SUBJECT: ISSUANCE OF AMENDMENT NO. 38 TO FACILITY OPERATING LICENSE NO. NPF-41, AMENDMENT NO. 25 TO FACILITY OPERATING LICENSE NO. NPF-51, AND AMENDMENT NO. 14 TO FACILITY OPERATING LICENSE NO. NPF-74, FOR THE PALO VERDE NUCLEAR GENERATING STATION, UNITS 1, 2, AND 3, RESPECTIVELY (TAC NOS. 68394, 68395 AND 68396)

The amendments revise Technical Specifications 3.2.3 and 4.2.3.2 and adds Figure 3.2-1A to modify the azimuthal power tilt TS to require the measured power tilt to be equal to or less than the Core Protection Calculator allowance and the limit in Figure 3.2-1A when the Core Operating Limit Supervisory System is in service. In addition, the azimuthal power tilt limit is increased for Unit 2 only.

Amendment No. 38  
License No. NPF-41

Amendment No. 25  
License No. NPF-51

FIGURE 3.2 - 1A  
 AZIMUTHAL POWER TILT LIMIT  
 VS  
 THERMAL POWER  
 (COLSS IN SERVICE)

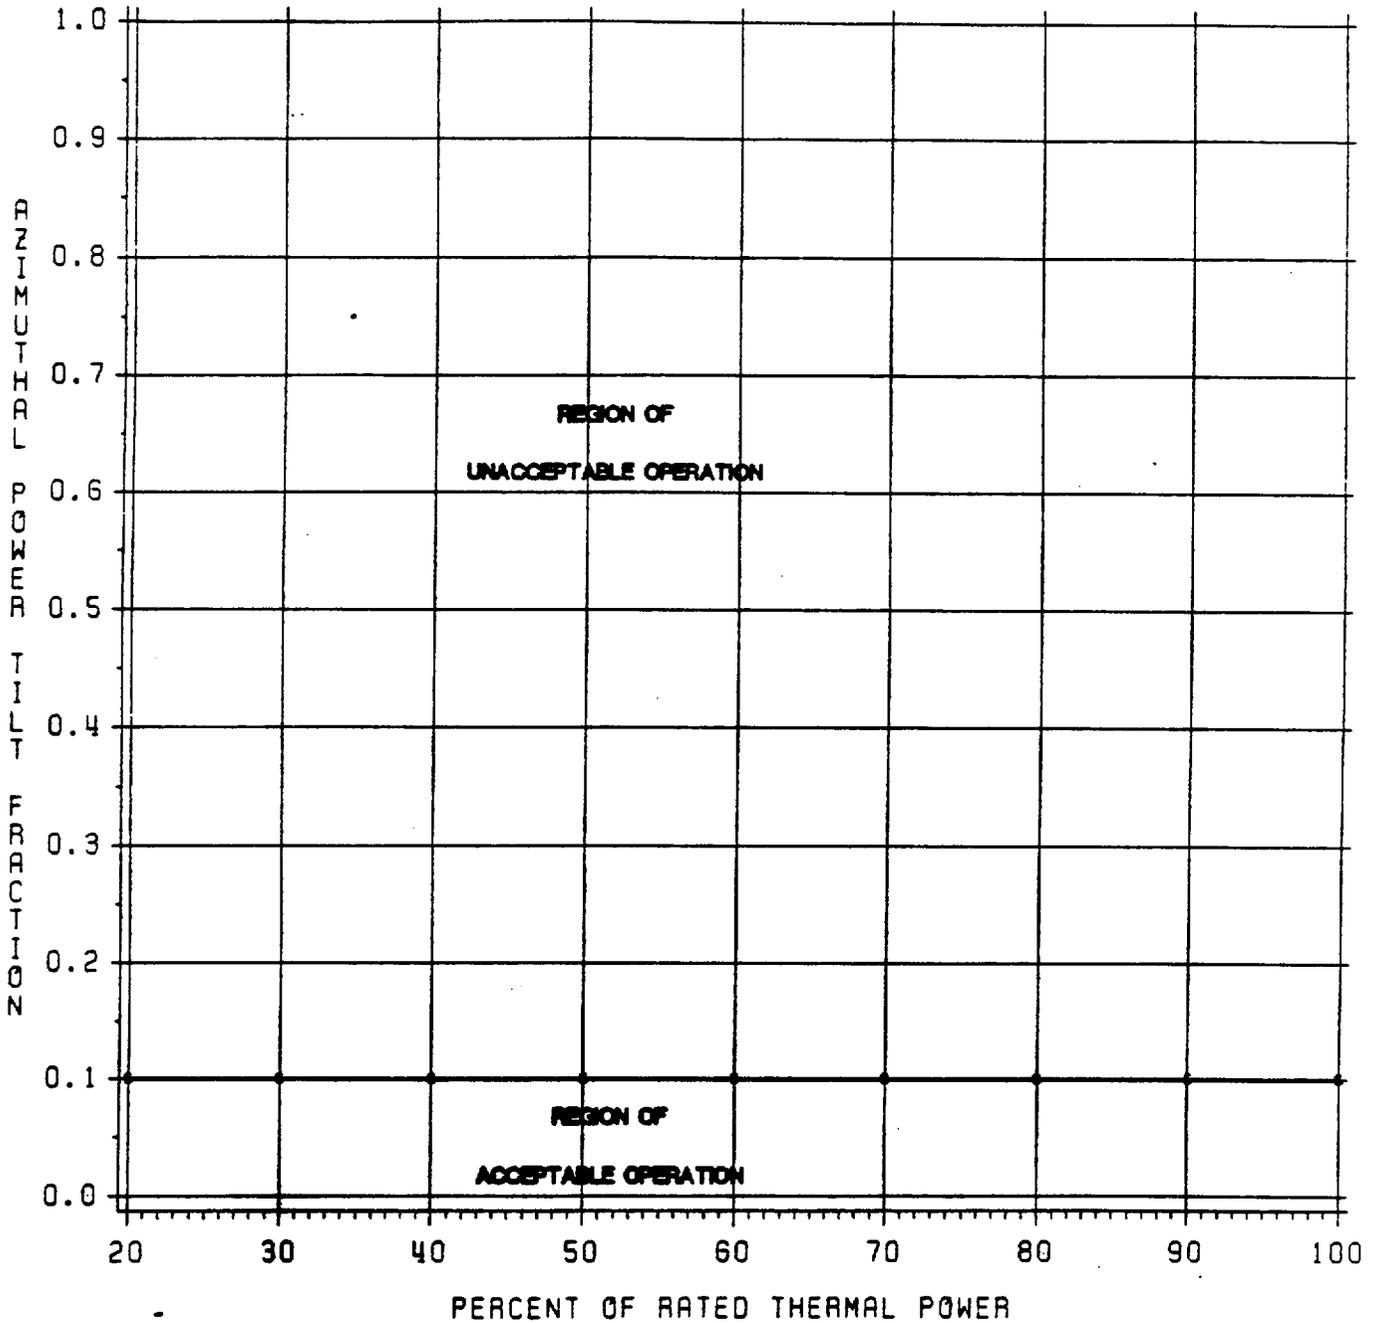
- a. The AZIMUTHAL POWER TILT Allowance used in the Core Protection Calculators (CPCs), and
- b.1. The limit in Figure 3.2-1A with COLSS in service, or
- b.2.  $T_q \leq 0.10$  with COLSS out of service.

- b. With the measured AZIMUTHAL POWER TILT determined to exceed the limit in Figure 3.2-1A with COLSS in service or 0.10 with COLSS out of service:
  1. Due to misalignment of either a part-length or full-length CEA, within 30 minutes verify that the Core Operating Limit Supervisory System (COLSS) (when COLSS is being used to monitor the core power distribution per Specifications 4.2.1 and 4.2.4) is detecting the CEA misalignment.

FIGURE 3.2 - 1A  
 AZIMUTHAL POWER TILT LIMIT  
 VS  
 THERMAL POWER  
 (COLSS IN SERVICE)

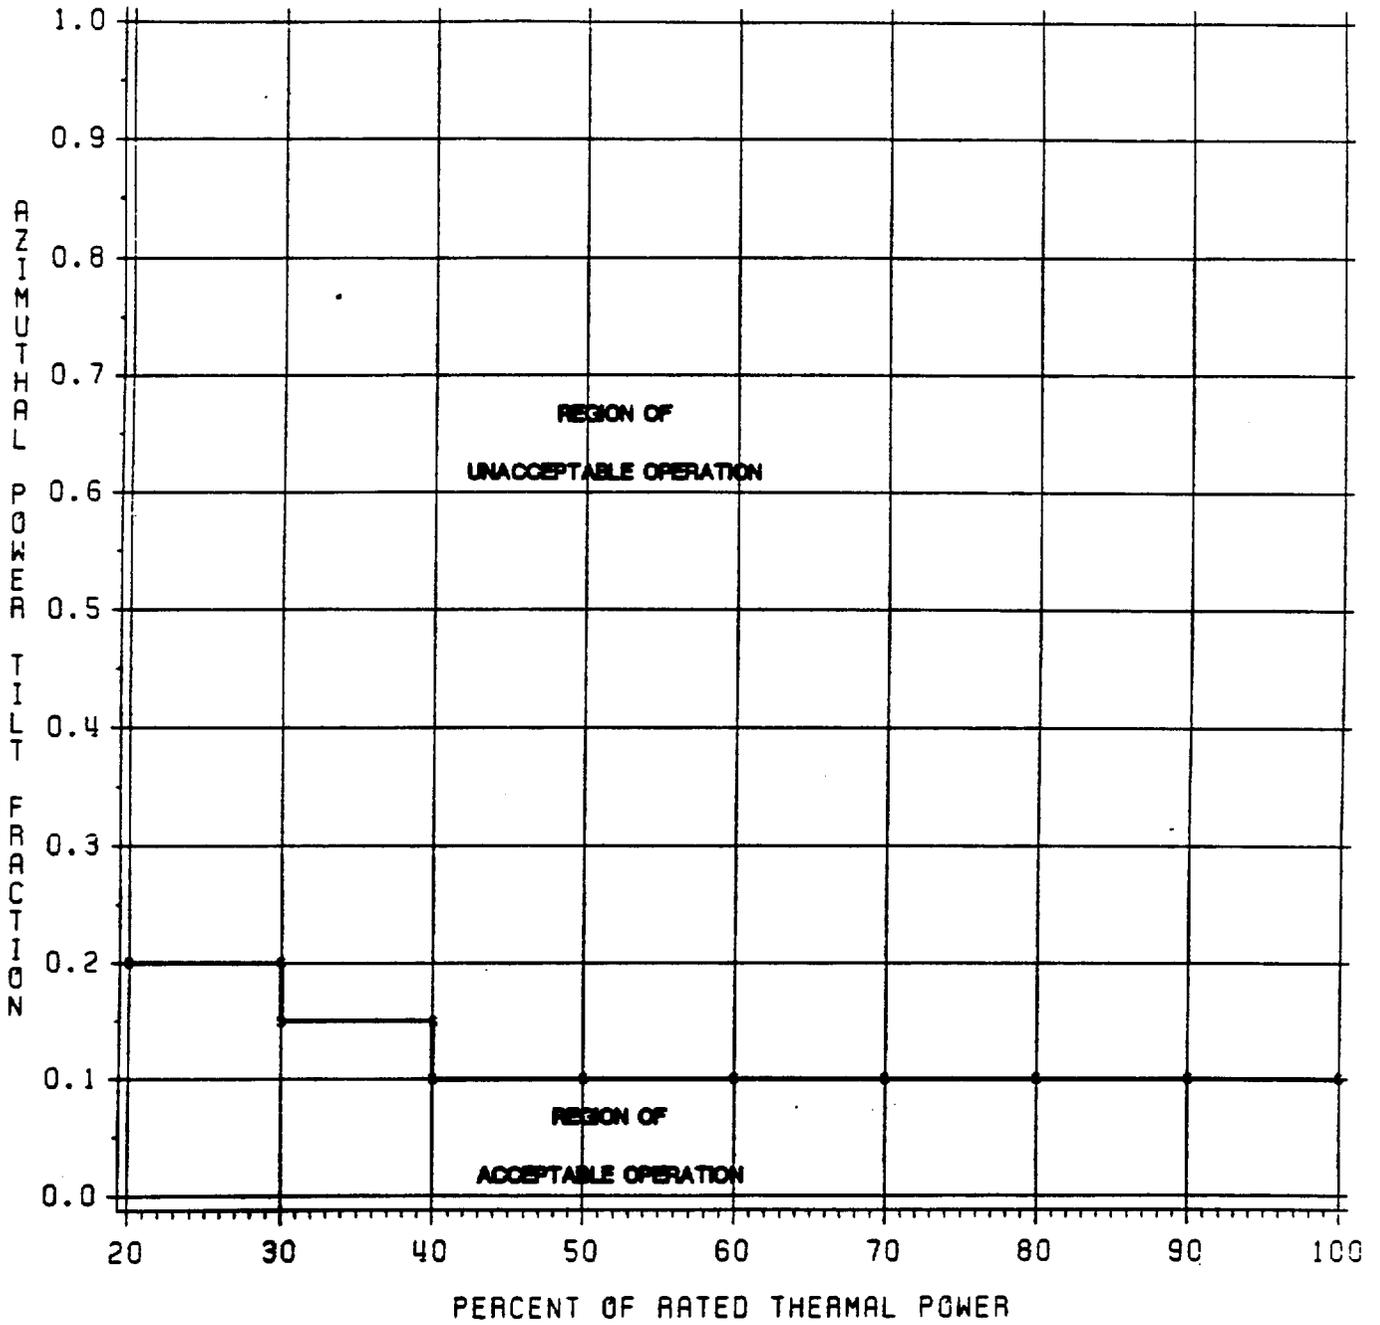
- a. The AZIMUTHAL POWER TILT Allowance used in the Core Protection Calculators (CPCs), and
  - b.1. The limit in Figure 3.2-1A with COLSS in service, or
  - b.2.  $T_q \leq 0.10$  with COLSS out of service.

- b. With the measured AZIMUTHAL POWER TILT determined to exceed the limit in Figure 3.2-1A with COLSS in service or 0.10 with COLSS out of service:
  1. Due to misalignment of either a part-length or full-length CEA, within 30 minutes verify that the Core Operating Limit Supervisory System (COLSS) (when COLSS is being used to monitor the core power distribution per Specifications 4.2.1 and 4.2.4) is detecting the CEA misalignment.

The wording change regarding the status of the COLSS adds clarity to the TS and is acceptable. Increasing Unit 2's azimuthal power tilt limits for COLSS in service for operation below 40% power will allow the operators to better mitigate the consequence of xenon transients occurring below 40%

FIGURE 3.2-1A  
 AZIMUTHAL POWER TILT LIMIT  
 VS  
 THERMAL POWER  
 (COLSS IN SERVICE)

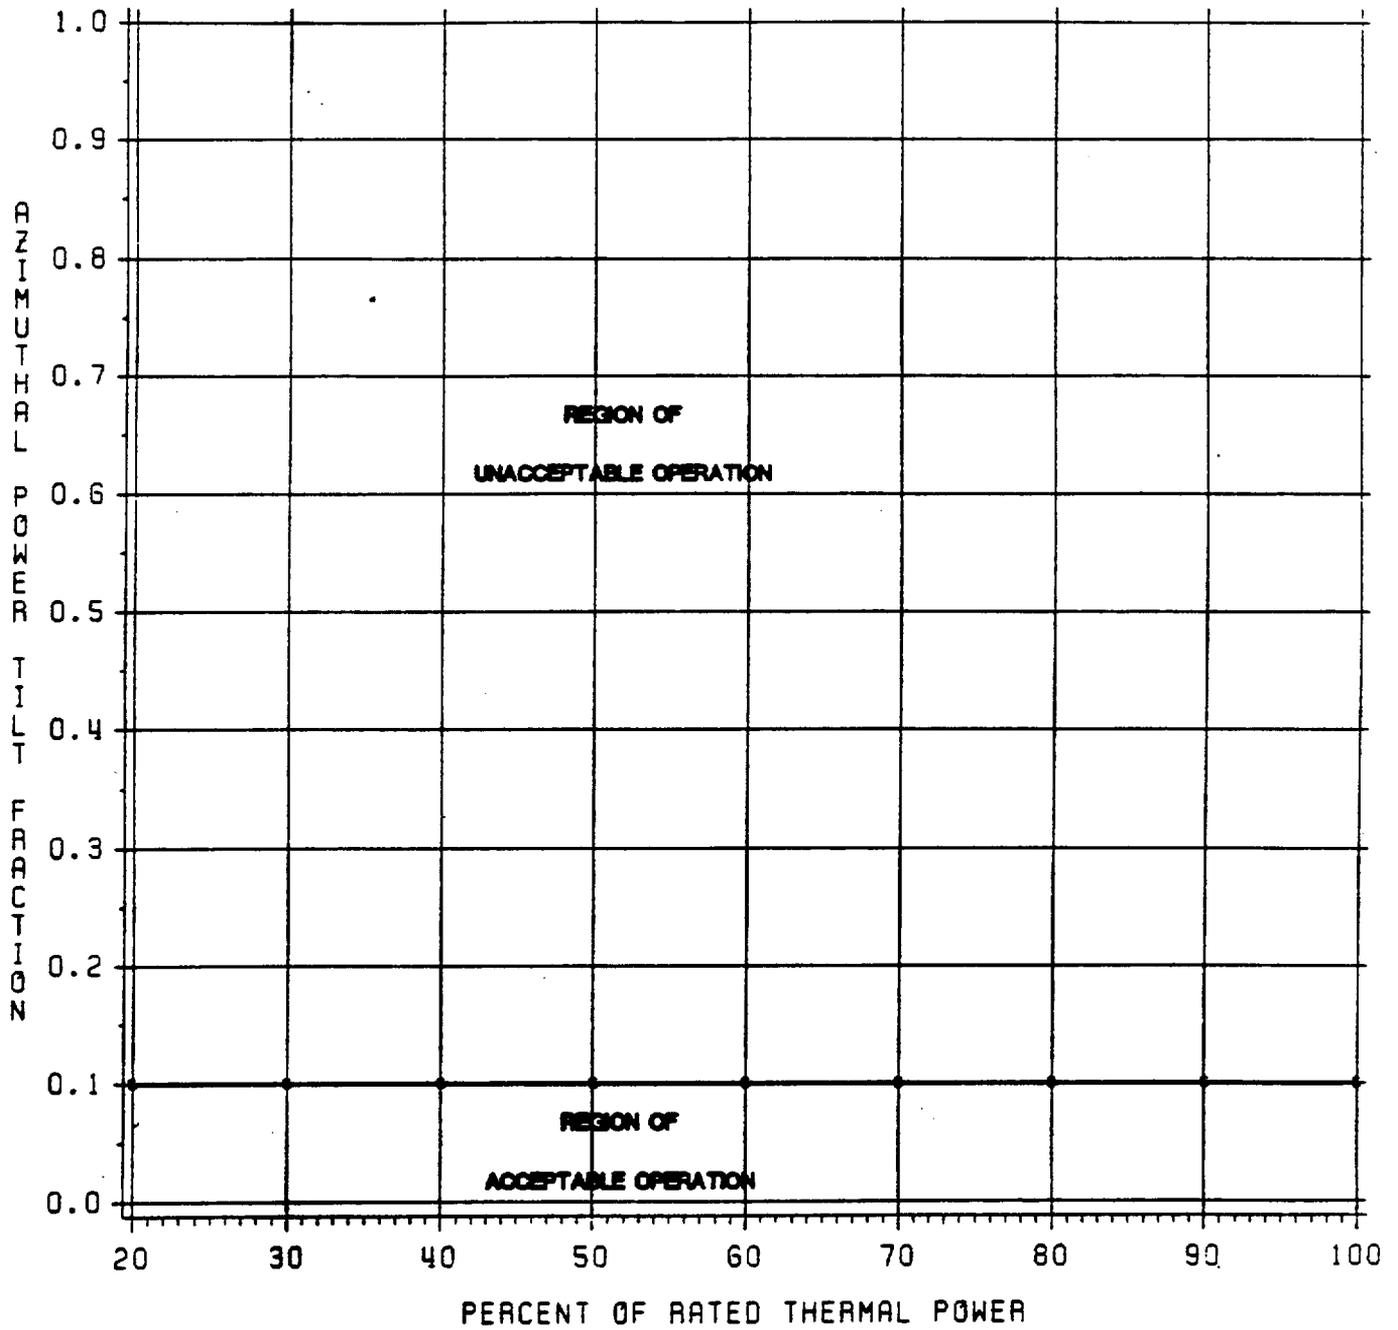
- a. The AZIMUTHAL POWER TILT Allowance used in the Core Protection Calculators (CPCs), and
- b.1. The limit in Figure 3.2-1A with COLSS in service, or
- b.2.  $T_q \leq 0.10$  with COLSS out of service.

- b. With the measured AZIMUTHAL POWER TILT determined to exceed the limit in Figure 3.2-1A with COLSS in service or 0.10 with COLSS out of service.
  1. Due to misalignment of either a part-length or full-length CEA, within 30 minutes verify that the Core Operating Limit Supervisory System (COLSS) (when COLSS is being used to monitor the core power distribution per Specifications 4.2.1 and 4.2.4) is detecting the CEA misalignment.
